UNITED STATES PATENT AND TRADEMARK OFFICE

10/589,203

Office Action Summary	Application No. 10/589,203	Applicant(s) VANDAELE, HUGO	
	Examiner Terressa M. Boykin	Art Unit 1796

FIG. 3

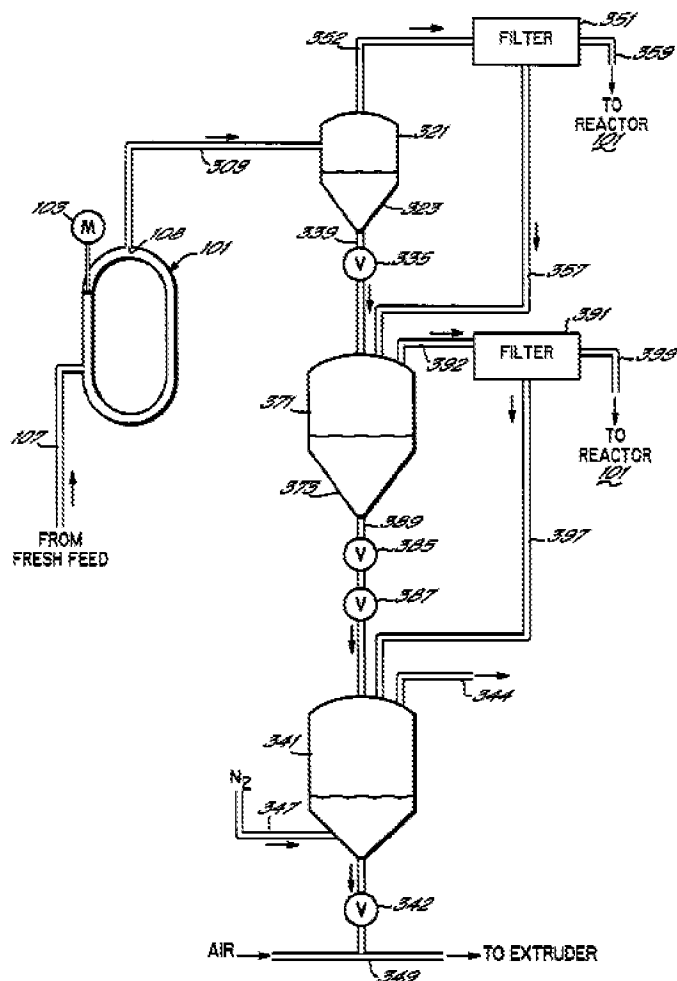
Claims 17-33 are rejected under 35 U.S.C. 102(b) as anticipated by or, in the alternative, under 35 U.S.C. 103(a) as obvious over USP 6566460 see abstract, figure 3 and example 3.

Referring to FIG. 3,

the reactor operation and slurry take-off are as described in Examples 1 and 2. The slurry enters high-pressure non-cyclonic flash vessel 321 where the pressure is approximately 220 psig. An overhead stream consisting of ethylene, isobutane and lights exits via line 352 through bag filter 351 to remove any entrained polymer particles, continues through line 359 and is cooled and liquefied in a heat exchanger (not shown). A portion of lights can be vented before the stream is pumped back to the reactor; no compressor is needed. Vessel 321 can be about six feet in diameter and ten feet high,

tangent to tangent. Polymer powder accumulates in lower section 323 which is conical at an angle of at least about 60 degrees. Control of rotary valve 335 in line 339 in response to a minimum level of polymer powder in vessel 321 provides a dynamic seal between vessel 321 and downstream vessels, similar to that described in Example 2. A substitute for rotary valve 335 could be two ball valve in series operated out of phase.

In view of the above, there appears to be no significant difference between the reference and that which is claimed by applicant(s). Any differences not specifically mentioned appear to be conventional and inherent. Any properties or characteristics inherent in the prior art, e.g. the type of measuring or sensing employed for the particular function one would desire to monitor. Thus, each reference containing such a monitoring device of some type would still anticipate the claimed invention. Note In re Swinehart, 169 USPQ 226. "It is elementary that the mere recitation of a newly discovered...property, inherently possessed by things in the prior art, does not cause claim drawn to those things to distinguish over the prior art". Since the disclosed monitoring device or measuring valves are expressed differently and thus yet appear to be inherent may be distinct from those claimed, it is incumbent upon applicant(s) to establish that they are in fact different and whether such difference is unobvious.
